TO: Keith Fronczak, Boulder Associates
FROM: Ashley Chasez, Planner I
DATE: December 11, 2023
SUBJECT: Parker Point F1 L10 - Medical Office Building
Review Comments 02

Staff Comments 02
SP23-058
Parker Point F1 L10 - Medical Office Building
12/11/2023

PARKER POINTE SUBDIVISION FILING NO. 2 - LOT 1A

SITE DEVELOPMENT PLAN

COVER SHEET

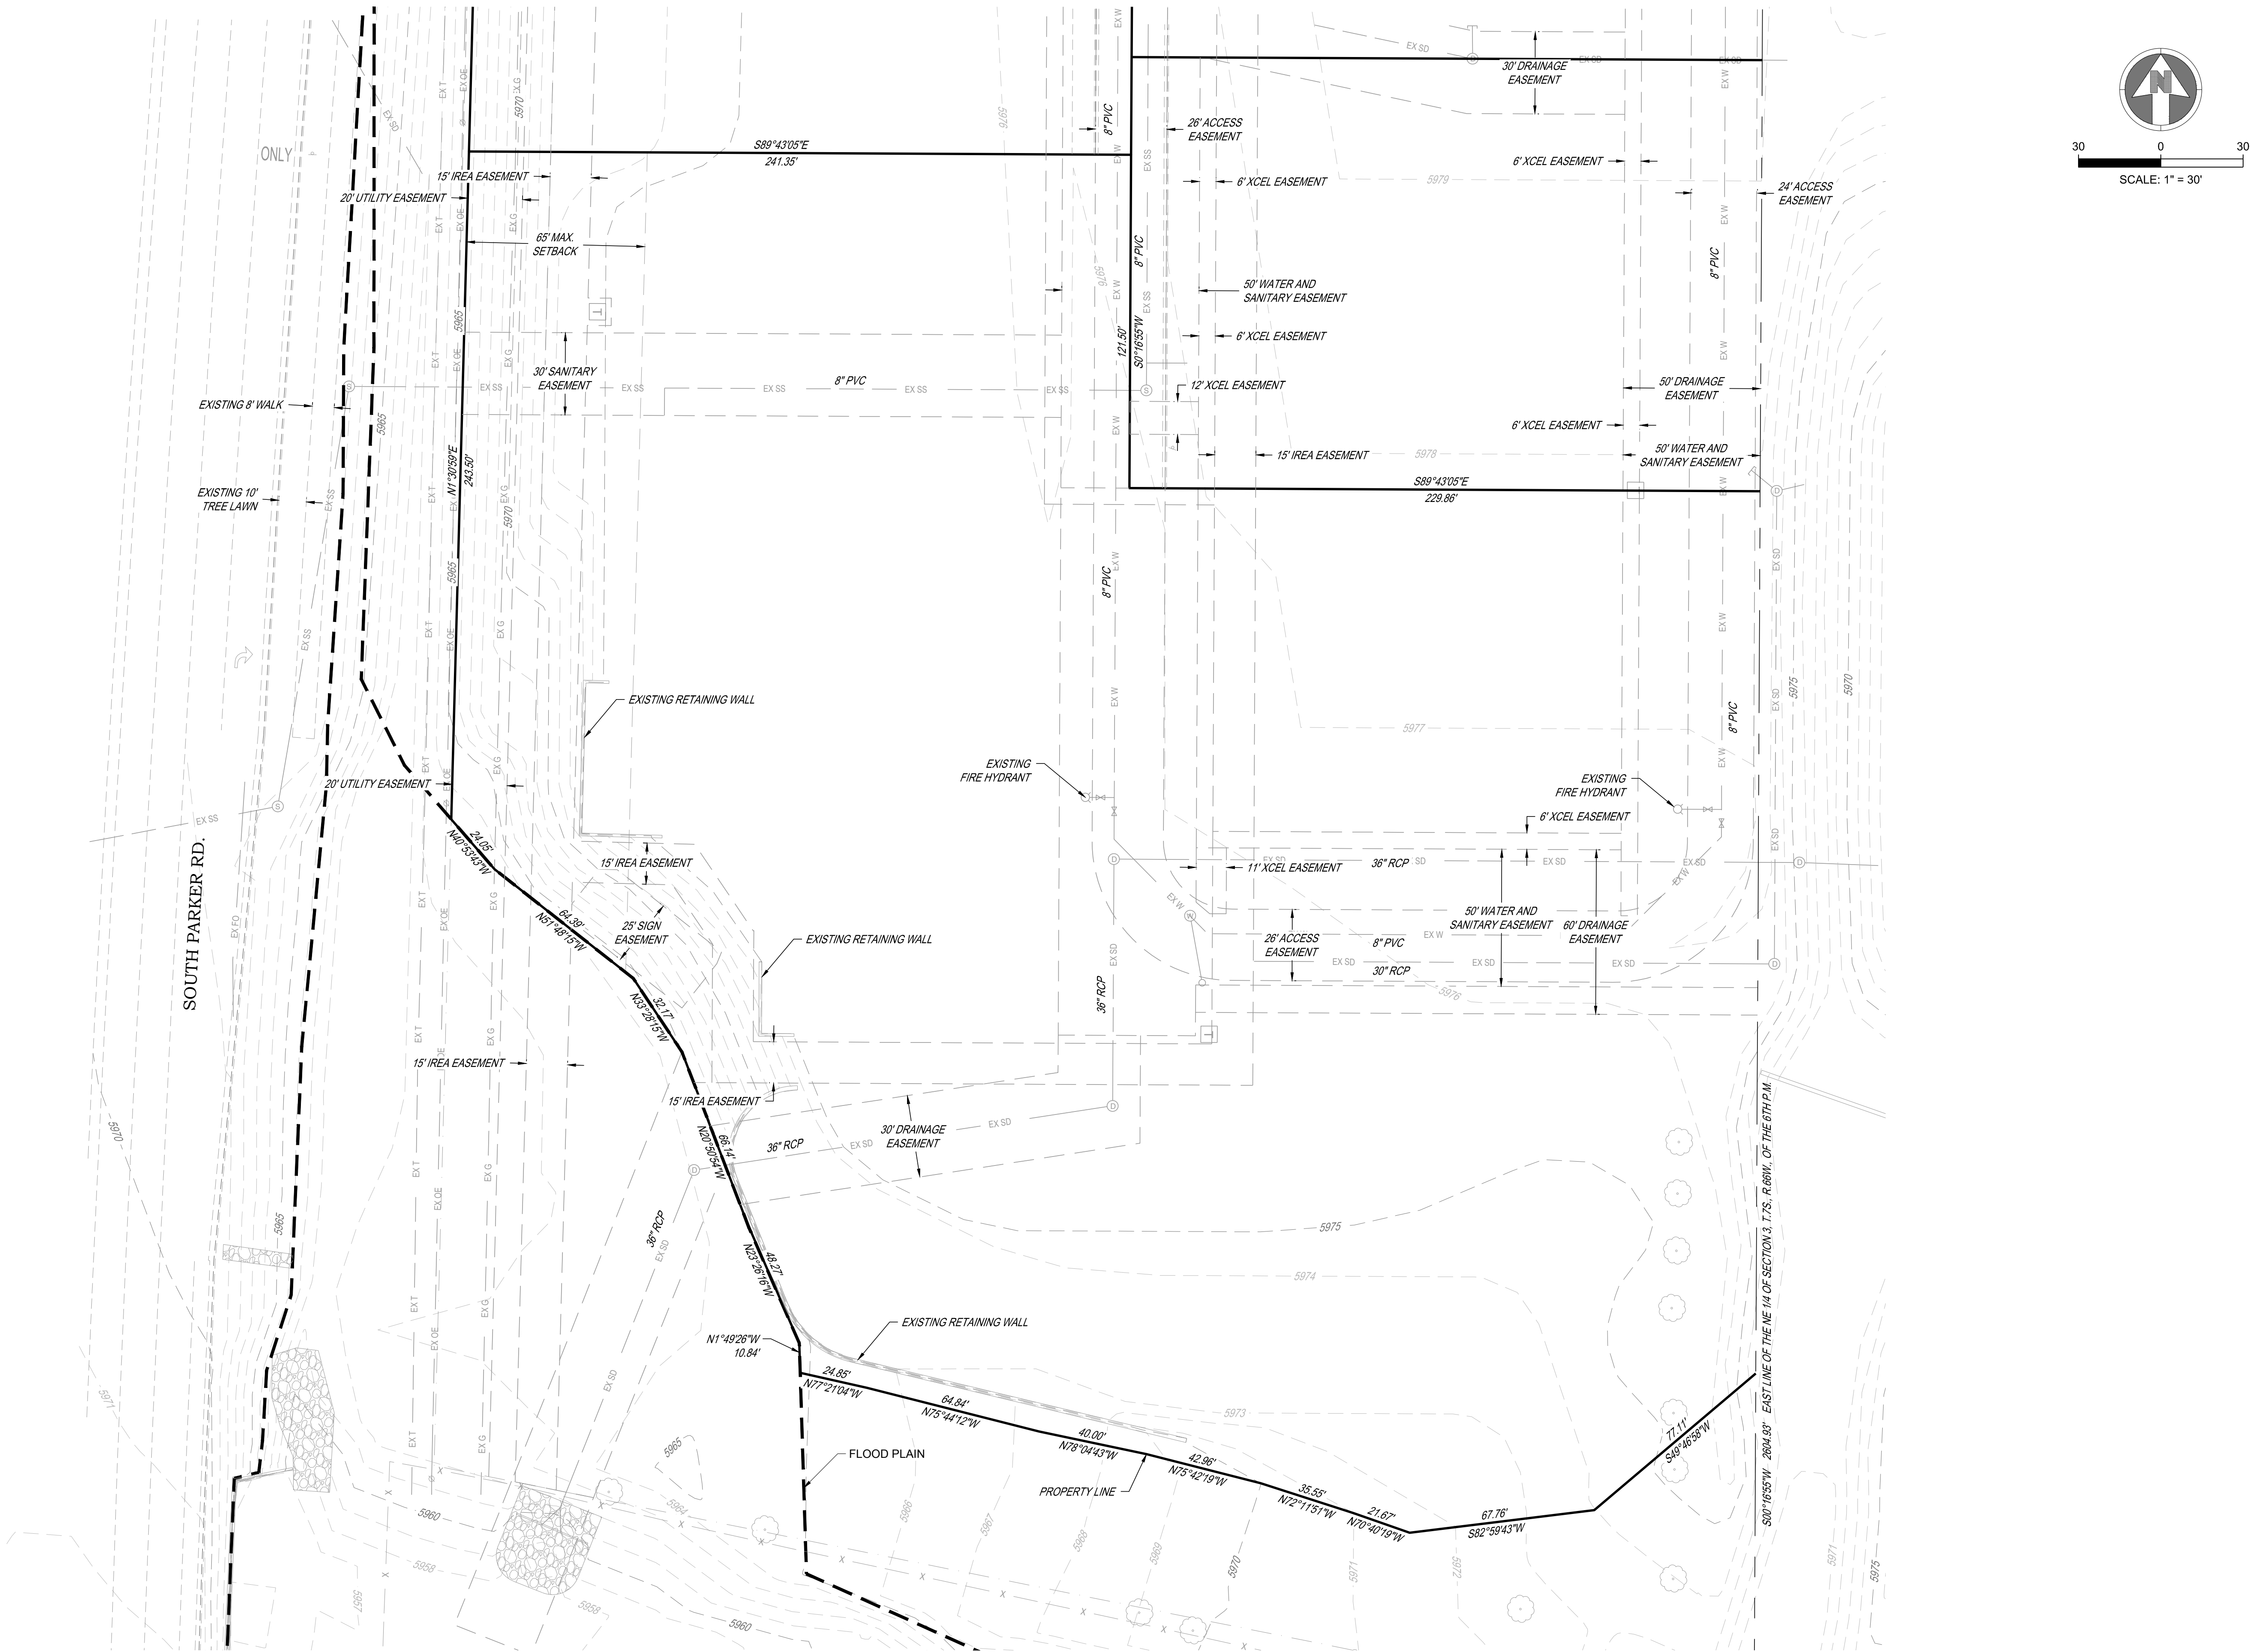
Include counts of the different widths of spots in this table.

SHEET TITLE
SITE PLAN

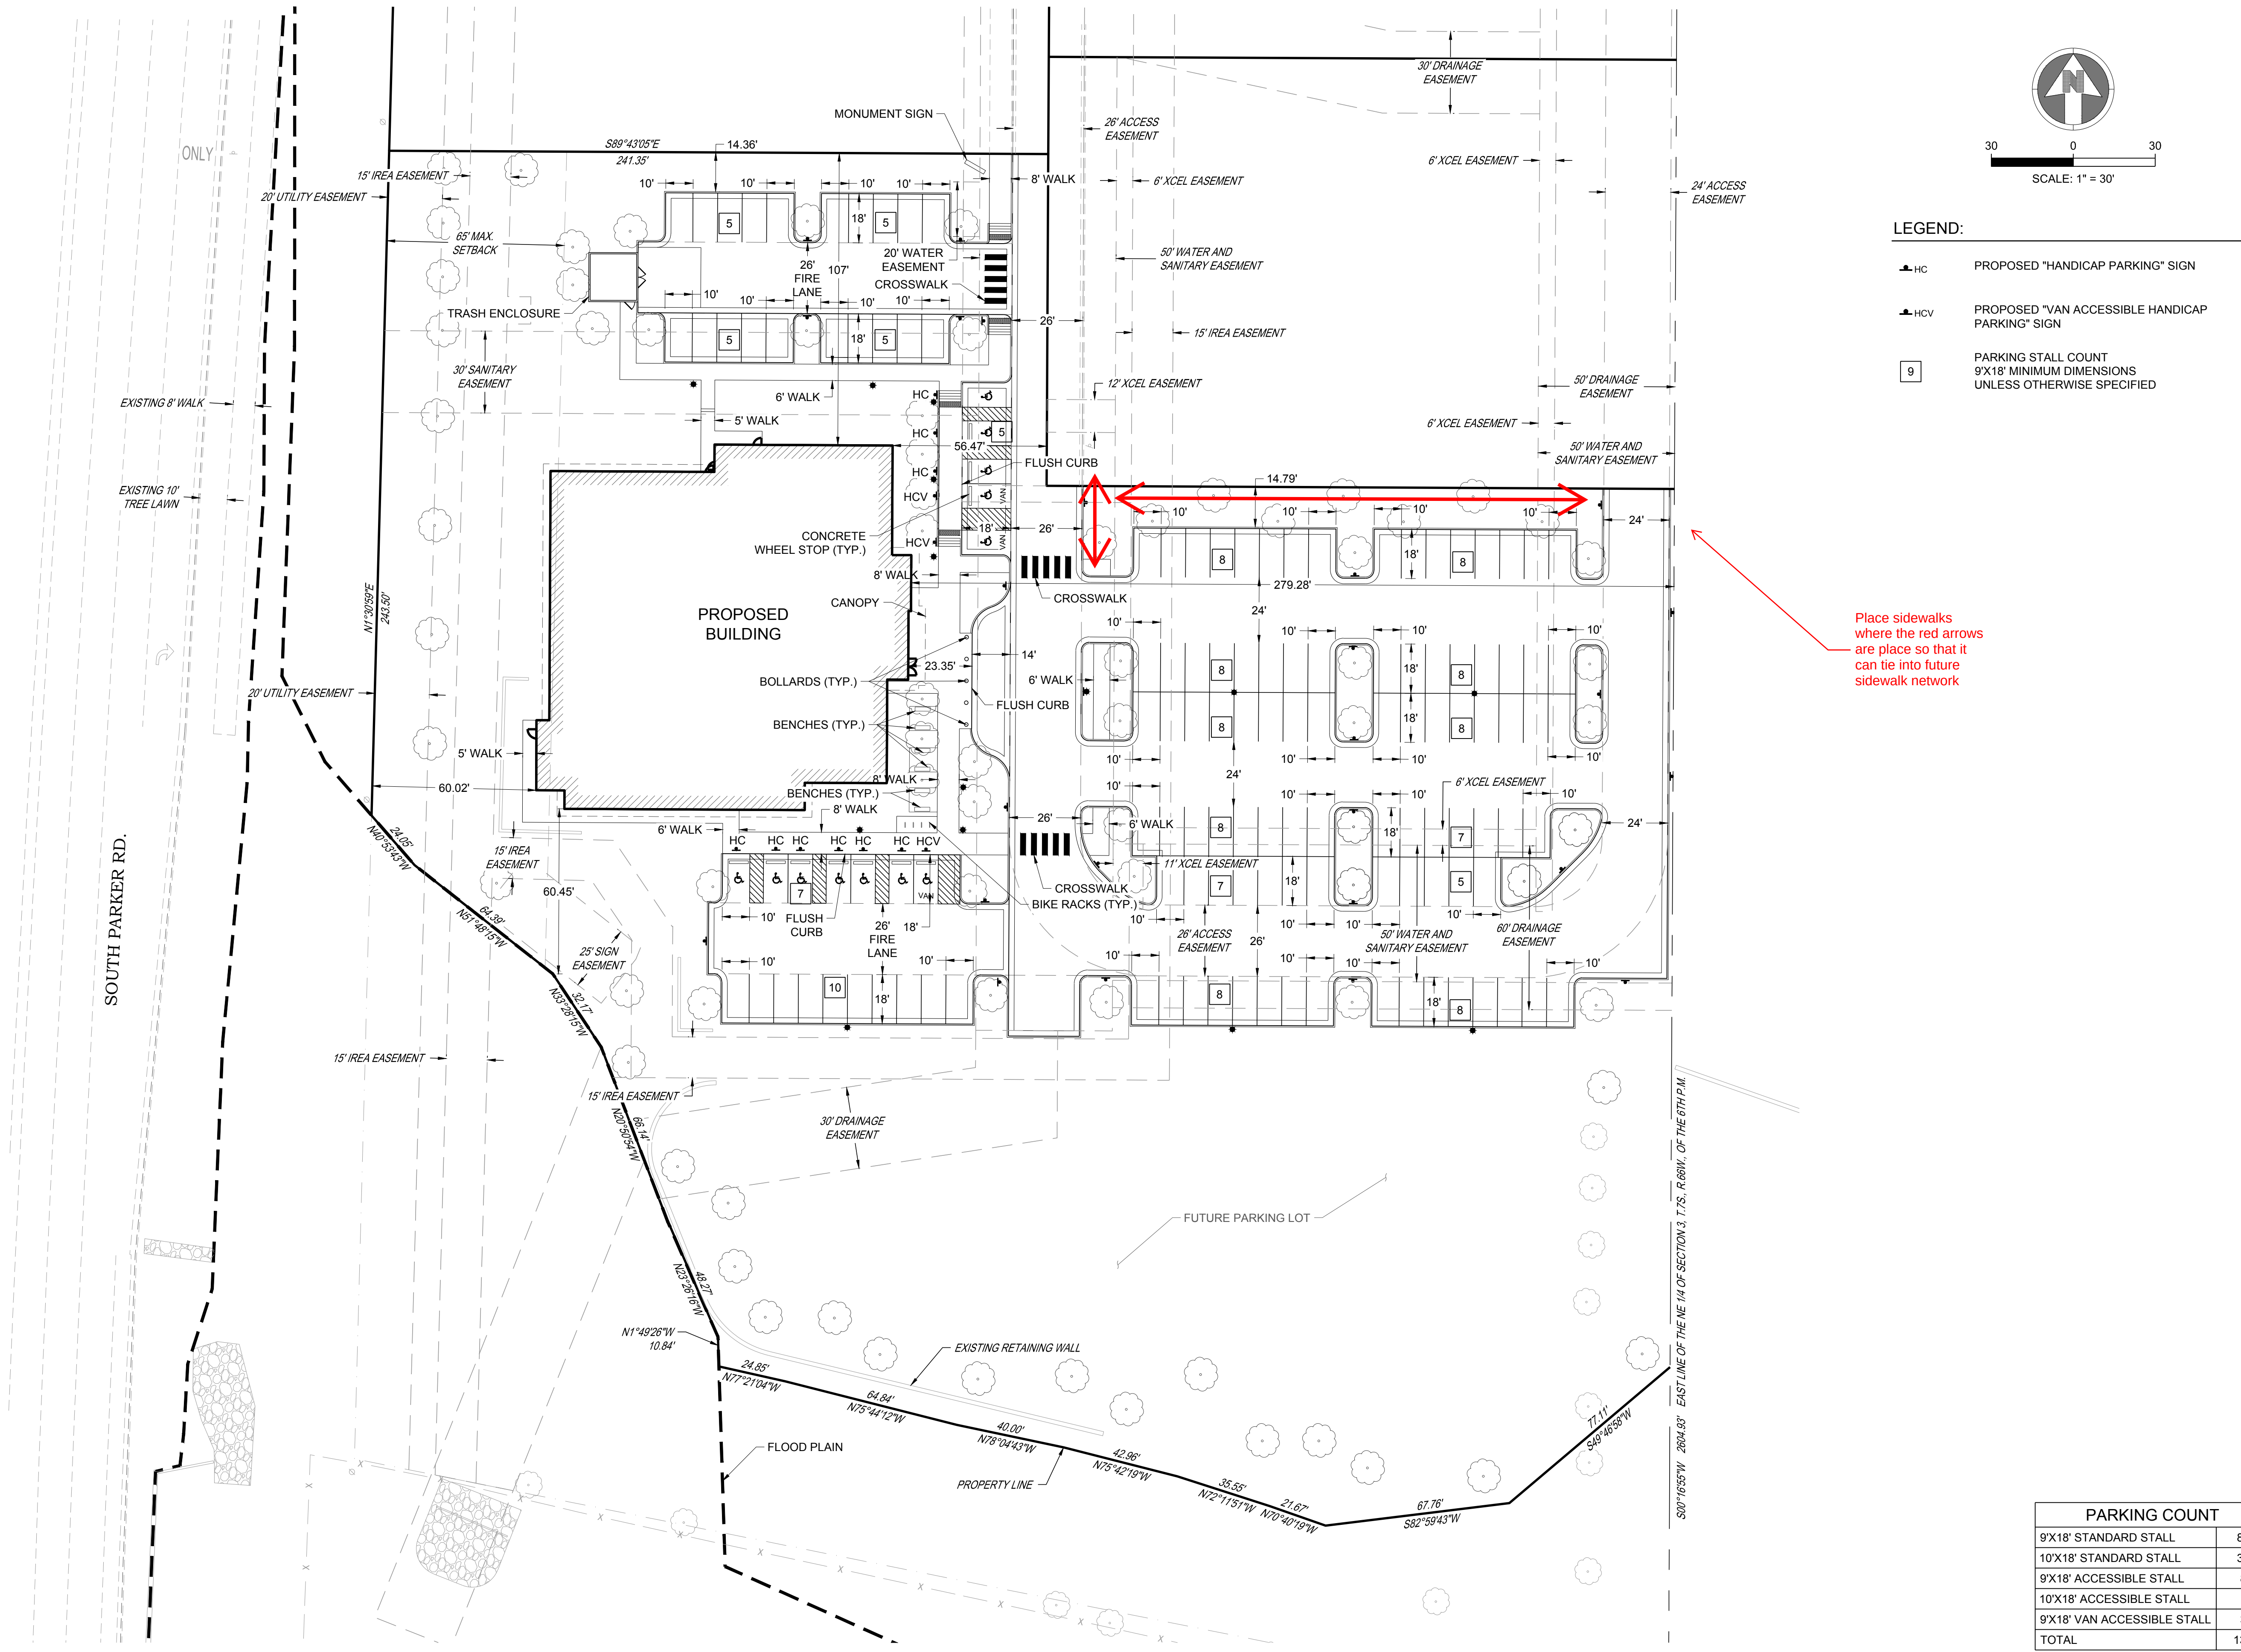
Place sidewalks
where the red arrows
are place so that it
can tie into future
sidewalk network

1 LANDSCAPE PLAN
5 SCALE: 1" = 20'

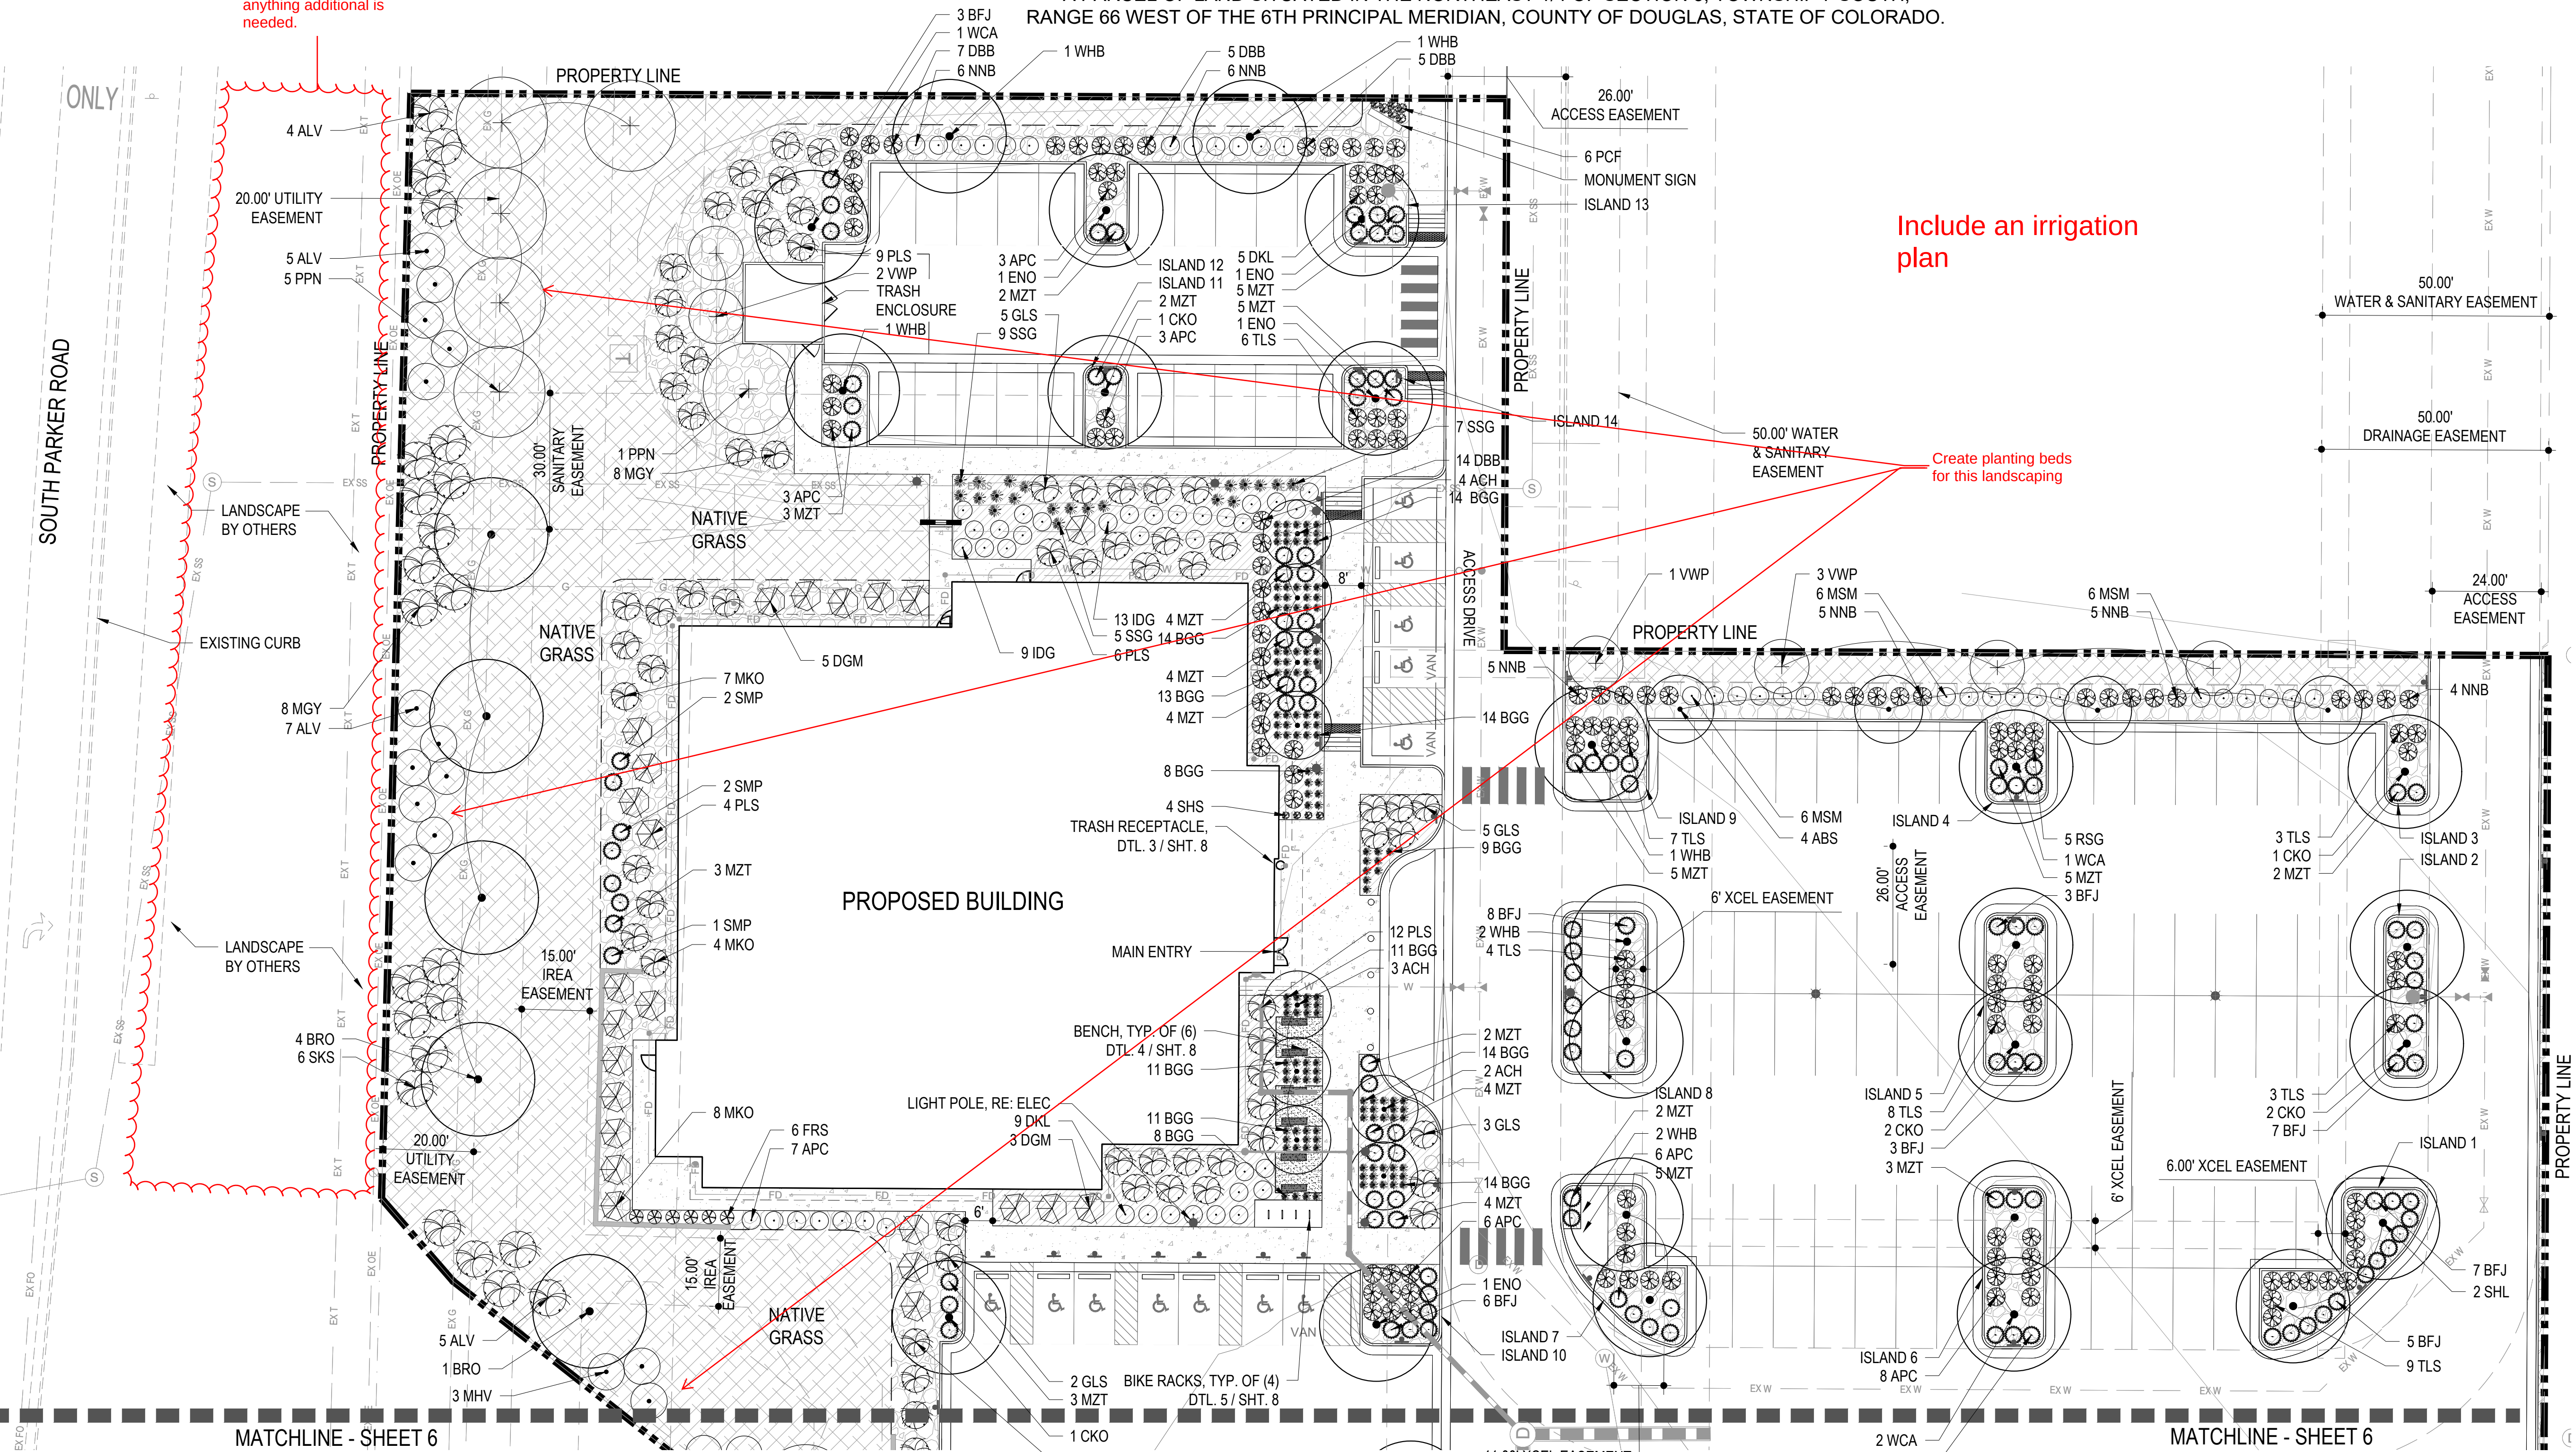
Show what is either existing or planned for this area. Grey back what isn't yours so I can determine if anything additional is needed.

Include an irrigation plan

Create planting beds for this landscaping
